London Borough of Lewisham

Written Representations

Thames Tideway Tunnel

**Submission Reference: LBLew04
Unique Reference Number: 10018610
National Infrastructure Directorate Project Ref: WW010001**

Photo 2 shows other mature trees on Croft Street that need protection during construction works.

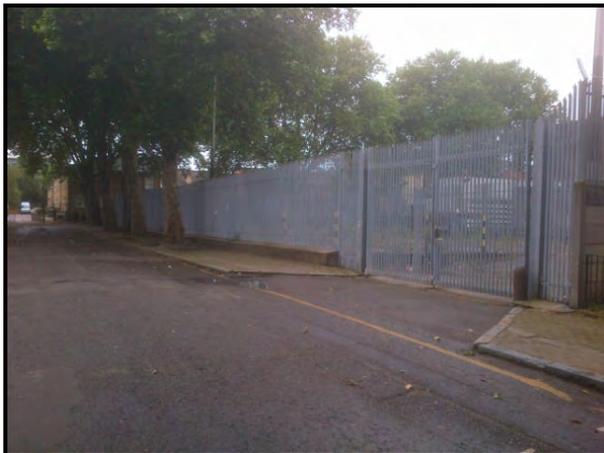
- 8.1.18 The Illustrative Construction and Highway Plans show a temporary construction access and permanent access from Croft Street that would miss an existing mature London Plane tree that is close to the boundary with No. 62 Croft Street (this tree is identified on the 'As Existing Site Features Plan' (DCO-PP-21X-EARPS-220002). See photo 1 in Annex 3.

1) Work Nos. 21a and 21b or any Ancillary Works shall not commence until a scheme setting out measures for the protection of existing trees in the public highway along Croft Street (as identified on Drawing DCO-PP-21X-EARPS-220002) has been submitted to and approved in writing by the relevant planning authority.

2) The approved tree protection measures shall be implemented and maintained in place throughout the construction work unless otherwise agreed in writing by the relevant planning authority.
